ISHAM, LINCOLN & BEALE
COUNSELORS AT LAW

June 20, 1983

DOCKET 50-155 - LICENSE DPR-6 - BIG ROCK POINT PLANT -
RESPONSE TO NRC STAFF CONCERNS - AMENDMENT 2 TO SPENT
FUEL RACK ADDITION - "CONSOLIDATED APPLICATION"

Subject: NRC DISCUSSION ITEM # 5:
SHEAR KEY CAPACITY

FIGURE 1 Node Points, Tributary Length & Effective Bearing Wall Area

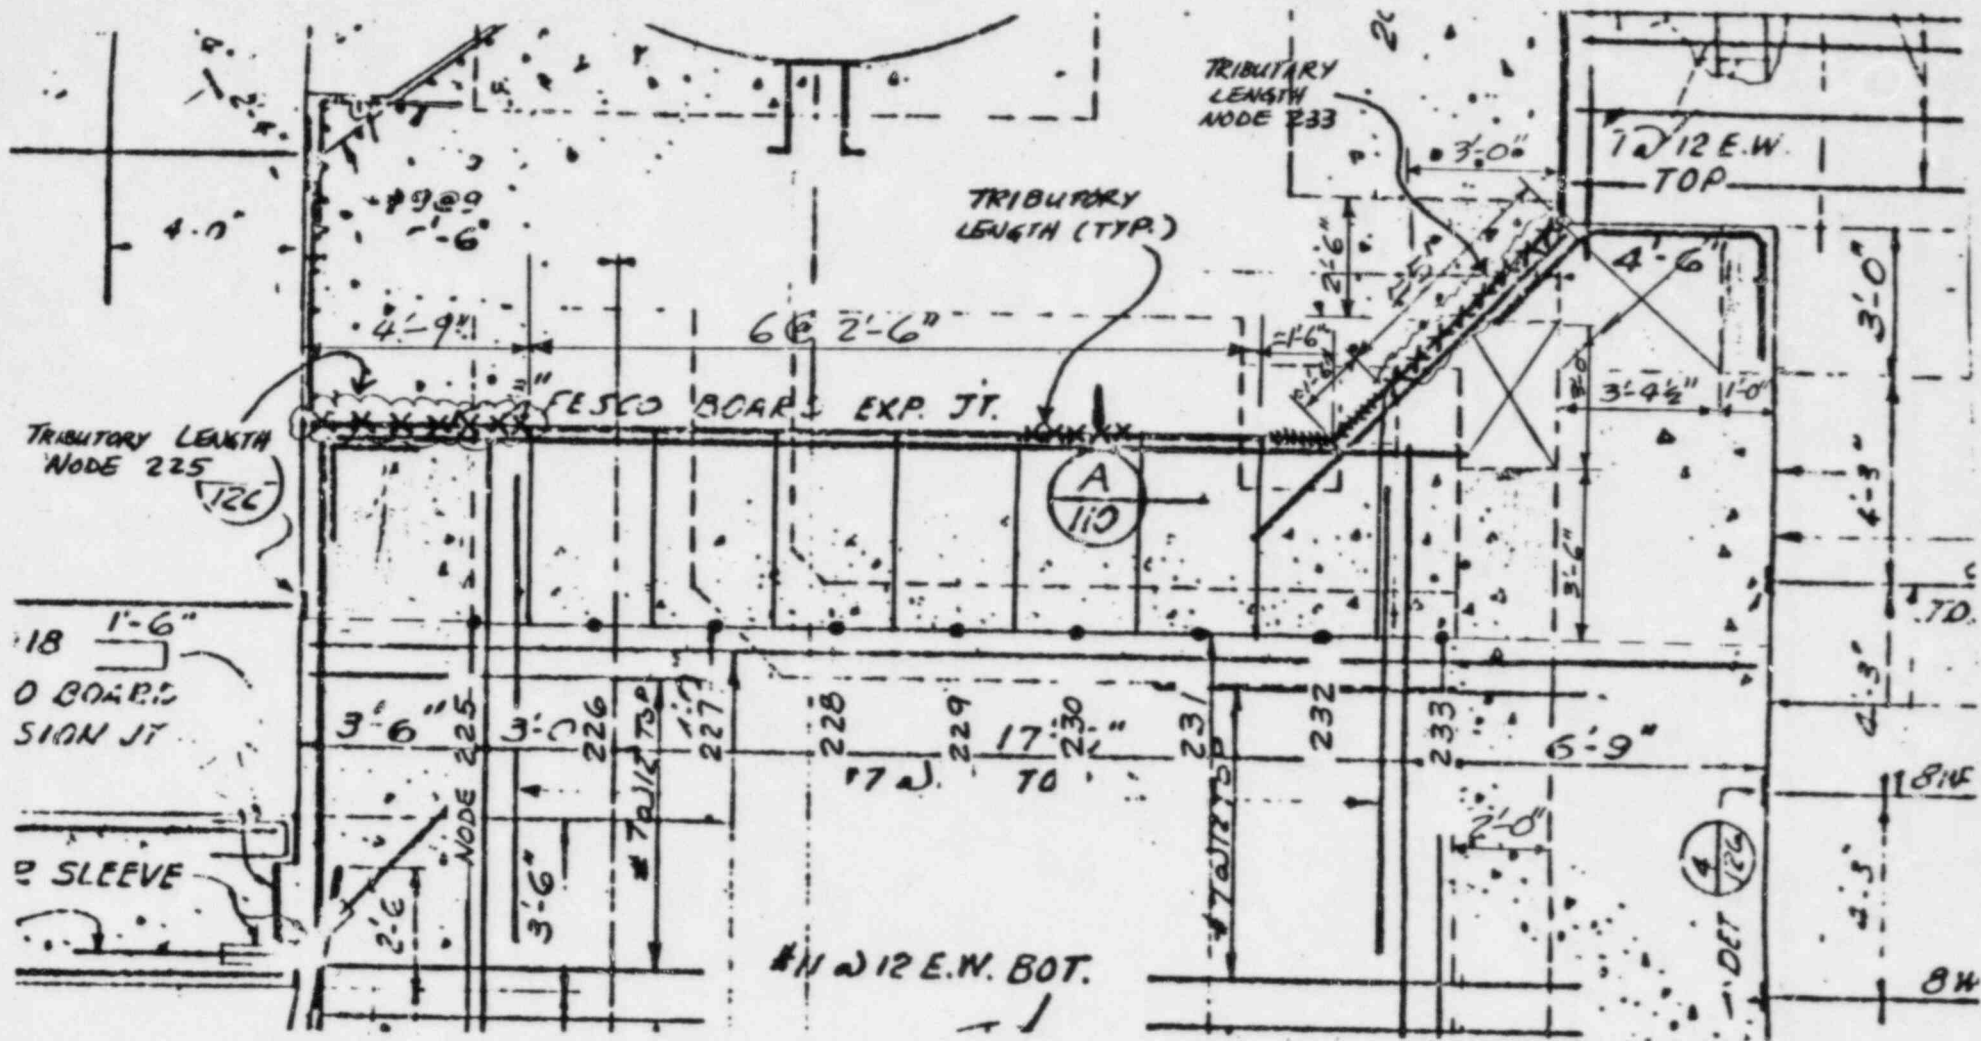
THE TRIBUTARY LENGTH OF EACH NODE IS AS SHOWN IN FIG. 1. THE CAPACITY OF EACH NODE IS TABULATED BELOW:

NODE	QVn	
	(EQ. 11-3)	(EQ. 11-6)
225	244,700 #	287,500 #
226 - 231	128,800 #	151,300 #
232	154,500 # 72,300 # (*)	181,600 # 90,800 # (*)
233	257,600 # 0 (*)	302,600 # 0 (*)

BIG ROCK POINT PLANT <small>CHALLENGER, MICHIGAN</small> CONSOLIDATED POWER COMPANY	
REACTOR BUILDING PLAN OF FLOOR @ EL 573'-0"	
3159	REVISED BY C-107
	NO. 6

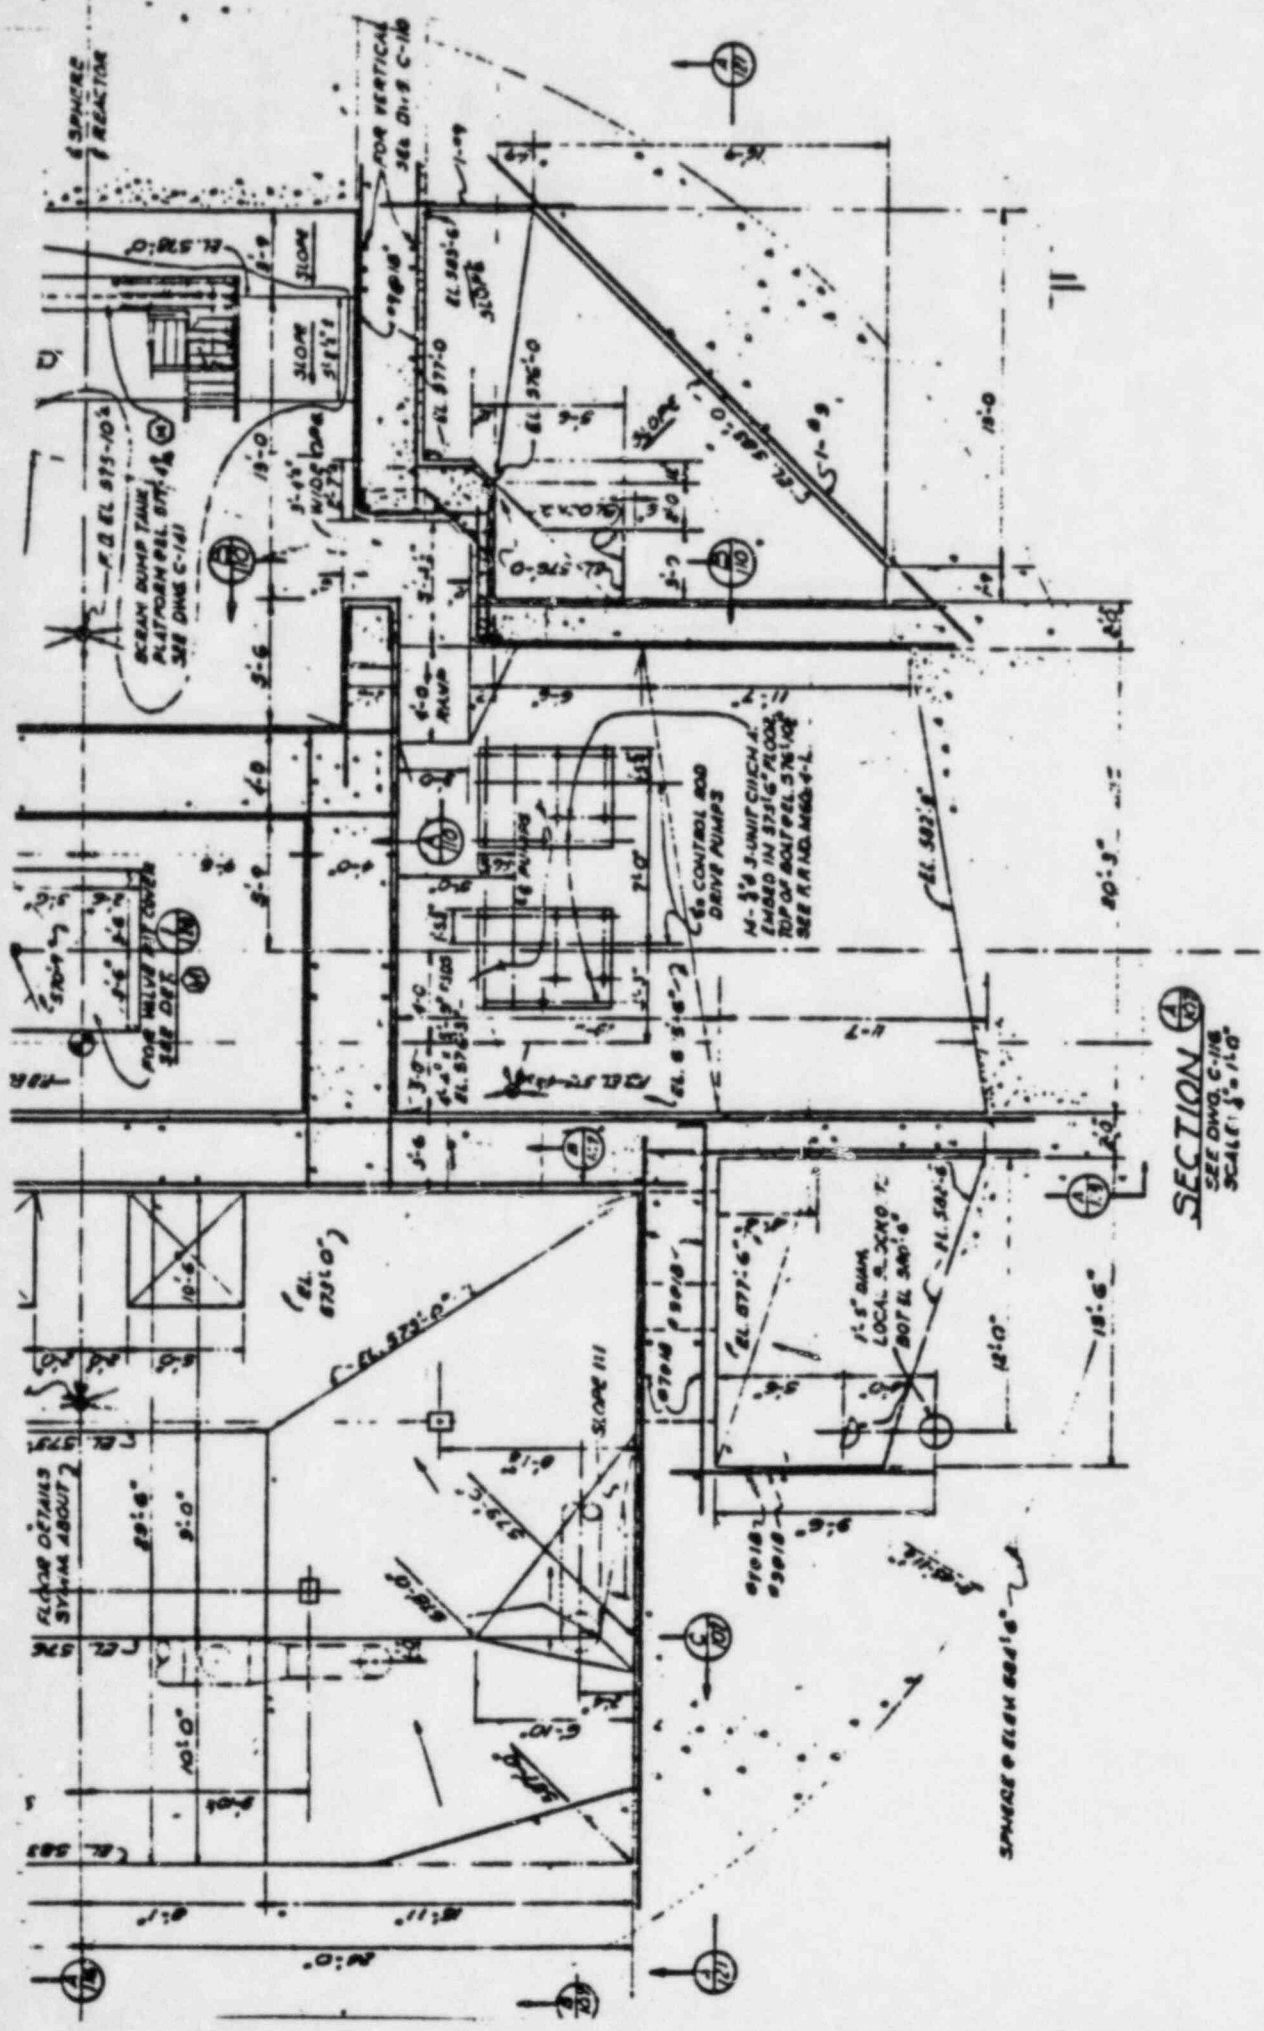
FURTHERMORE, THERE ARE WALLS SUPPORTING THE WEST POOL WALL ON ITS SOUTH & NORTH ENDS. (SEE C-113 AND C-107 attached, shade area) THE CONFIGURATION OF THESE WALLS DOES NOT LEND ITSELF TO 'EXACT' ANALYSIS. FOR THE PURPOSE OF THIS EVALUATION, THE FOLLOWING CONSERVATIVE METHOD WILL BE USED.

FROM C-117

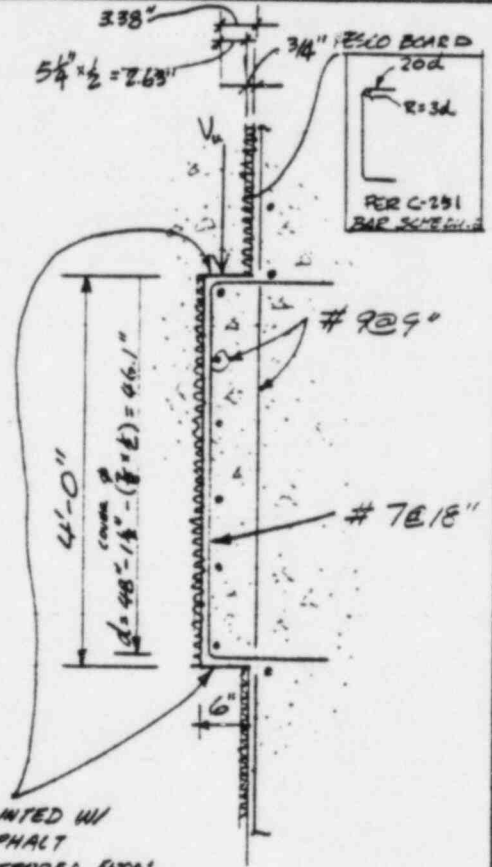
where $M_u = V_u \times 3.38"$ } SEE DIA.
 $d = 46.1"$ } AT RIGHT

NORTH BEARING WALL PLAN

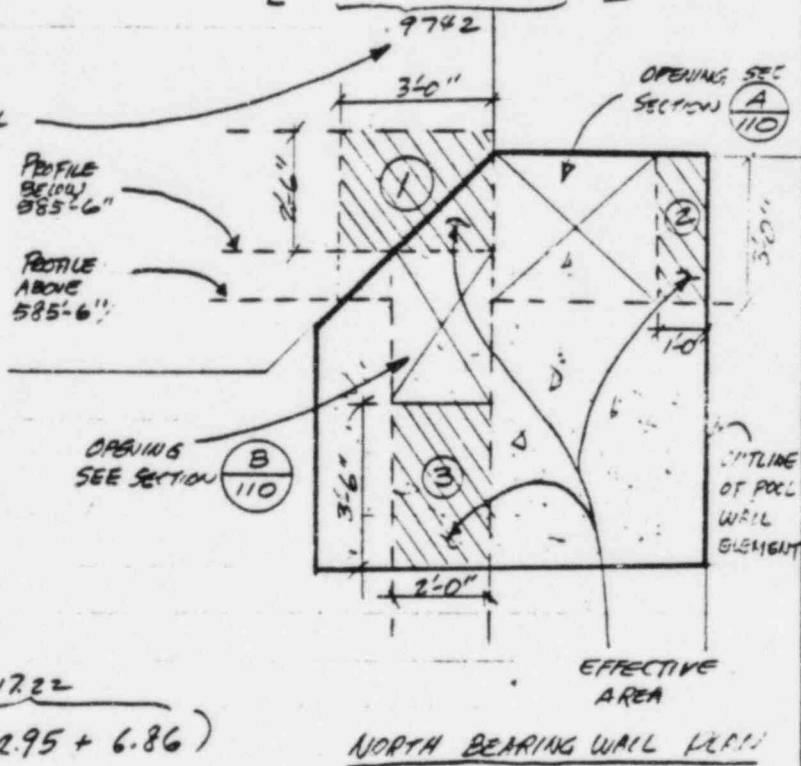
NORTH BEARING WALL
 (SEE DWGS. C-110 & C-107)

$$= \underline{2,864,000 \#}$$

FIGURE 1.

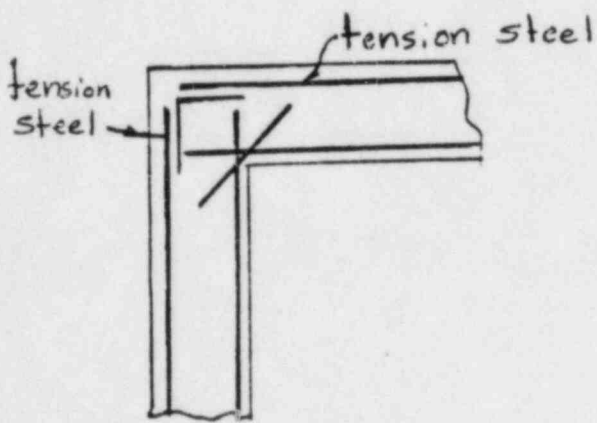
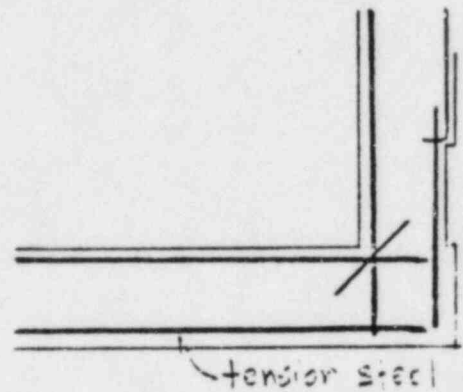
According to Park and Paulay (Reinforced Concrete Structures, John Wiley, 1975, pages 717-720 and Figure 13.52) adequate strength of joints for the assumption of rigidity between slabs can be expected only under the following conditions:

The type of joint that provides the rigid connection between adjacent slabs and the typical joints in the Big Rock Point pool structure are shown in Figure 1. In all the joints of the spent fuel pool the reinforcements at the outer faces of the walls and the floor are not continuous around the corner of the adjacent slabs. These joints are not close to the ideal or theoretical rigid joint shown in Figure 1. The splices, wherever used, appear to be just temperature and shrinkage reinforcement. Therefore, the joints between adjacent walls and between the walls and floor of the pool are in fact closer to pinned joints than rigid joints for thermal bending moments. The assumption of total rigidity of the joints between adjacent walls and between the west wall and the pool floor has resulted in a large overestimation of the thermal moments. In fact, had an analysis been performed assuming pinned conditions at these joints, the thermal

bending moments would be so small that the pool structure would not even crack. For the Big Rock spent fuel pool such an analysis is closer to reality. Because the evaluation of the degree of rigidity of the joints in an exact manner is extremely difficult to carry out and incorporate in a complicated analysis such as the one performed, the conservative analysis assuming total rigidity at the various joints described earlier was performed. The overestimation of the thermal moment more than compensates for the assumptions involved in the orthotropic property input as well as the manner in which the thermal gradient increments were applied during the analysis.

FIG. 1 WALLS LAID FLAT IN THE PLANE OF THE FLOOR

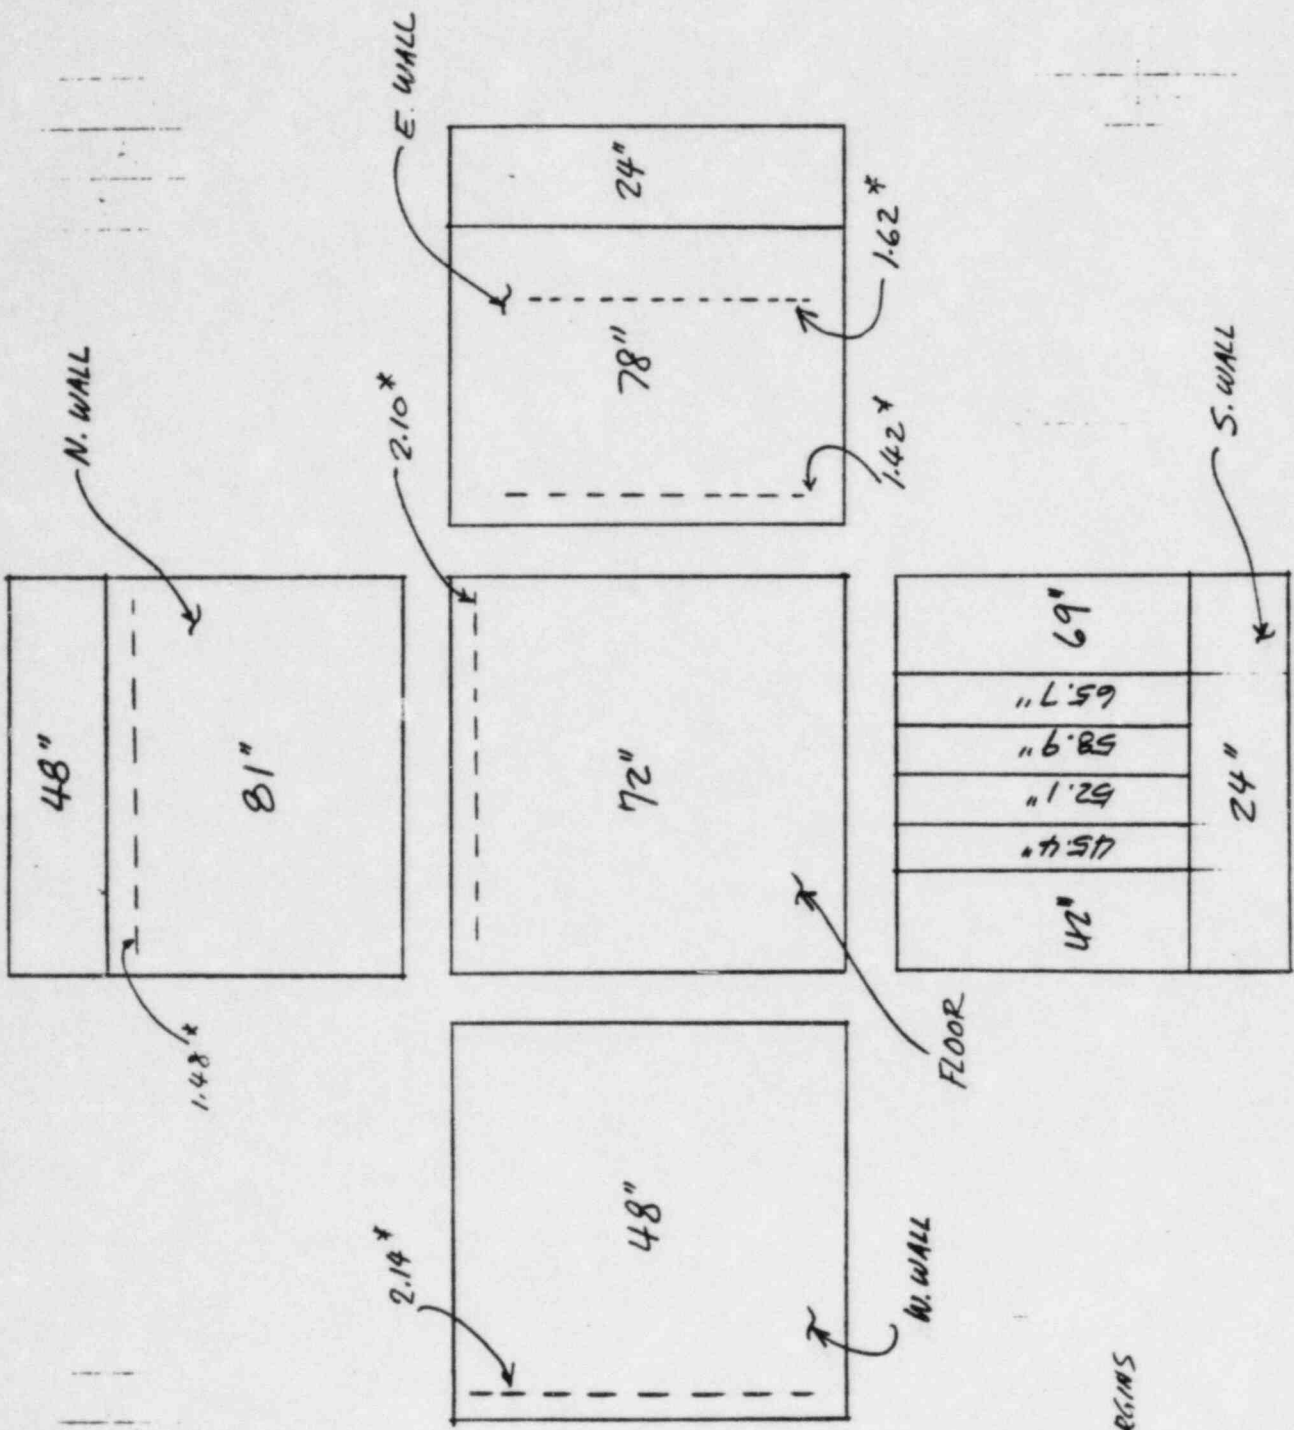
FIG. 1 (R.13) IS A PLOT OF THE FUEL POOL WITH ITS WALLS LAID FLAT IN THE PLANE OF POOL FLOOR. THE PROCEDURE FOR THIS ERROR ANALYSIS IS AS FOLLOWS:

1. IDENTIFY THE WALL JUNCTURE OF CONCERN, E.G., BETWEEN THE W. (48") AND THE N. (81") WALLS.
2. PICK A WALL AS A 'BENCHMARK' WALL AND IDENTIFY THE TIME WHEN i ($0.1 \Delta T_{max}$) (WHERE $i = 4, \dots, 10$) OCCURS. CALL THIS $t_{i,1}$ ($i = 4, \dots, 10$)
3. FROM THE ΔT CURVE OF THE OTHER WALL, IDENTIFY THE ΔT VALUES THAT CORRESPOND TO THE $t_{i,1}$ FROM THE LAST STEP.
4. CALCULATE THE % ERROR OF EACH TIME STEP i AS FOLLOWS:
